ULNRC-05242

**DOCKET NUMBER 50-483
CALLAWAY PLANT UNIT 1
UNION ELECTRIC CO.
FACILITY OPERATING LICENSE NPF-30
RESPONSE TO REQUEST FOR ADDITIONAL INFORMATION REACTOR
COOLANT SYSTEM LEAKAGE DETECTION INSTRUMENTATION**

RESPONSES TO REQUEST FOR ADDITIONAL INFORMATION

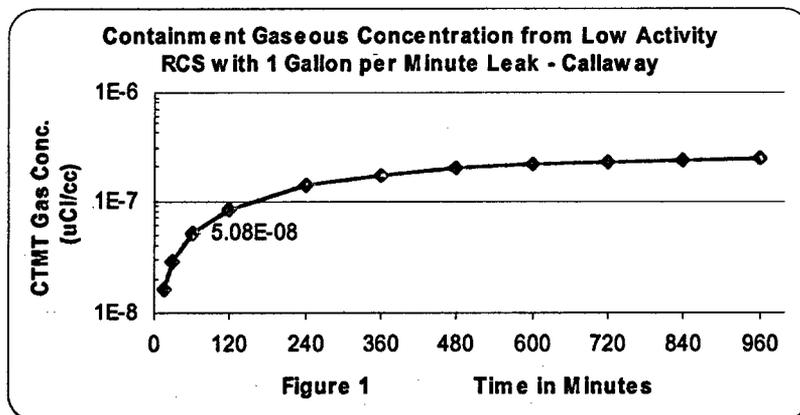
1. Given the discussion in the application on the containment atmosphere (gaseous) radioactivity monitor not being able to detect 1 gpm reactor coolant leakage in any way close to 1 hour for the current normal radioactivity levels in the reactor coolant, explain why this monitor is being retained in Limiting Condition for Operation (LCO) 3.4.15.

An evaluation performed in 2003 using current RCS activity levels resulted in a containment gaseous concentration at the end of 60 minutes to be $\sim 5.1E-08 \mu\text{Ci}/\text{cm}^3$ (see Figure 1 below). This evaluation confirmed the insensitivity of the containment atmosphere gaseous channels to low RCS activity.
